VEHICLE RECALL

G- 05516

G- 05517

**SUBJECT: SAFETY RECALL (U.S., EXPORT)
SPECIALTY MANUFACTURING CO. 5 Series Electric
Stop Arms on certain 3800 chassis, and CE, FE, and
RE School Buses built between 01/07/2002 and
06/22/2005**

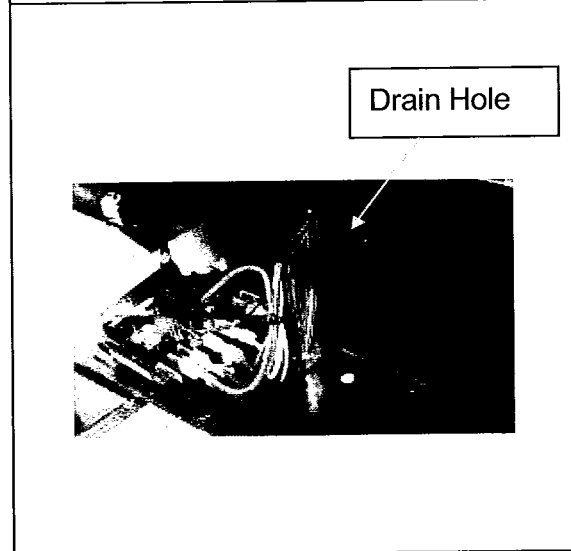
<p>15. Connect leads to new 005150 module as shown on schematic above. Leave two center tabs, +12VDC & GROUND, disconnected until module is fastened down in next steps. The yellow wire is no longer needed and can be tied back.</p>

16. Install new 005150 module into position as shown above. Timing mark **MUST** be facing toward the direction of the blade. (Ex. If blade is fully extended, timing mark must be turned to front of unit). Push module shaft through lower hinge hole. Fasten with (2) 11/32" hex nuts from original micro switch assy.

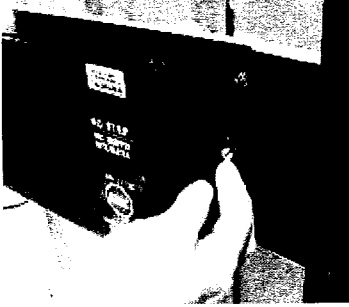
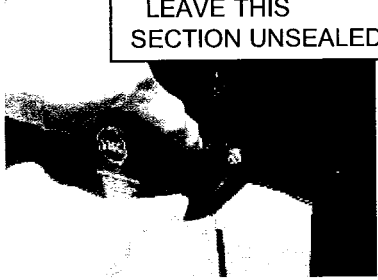
17. Connect +12VDC & GROUND per schematic.

18. Secure with 3/4" nut.

19. Tie wires. If unit does not have drain hole, add one.
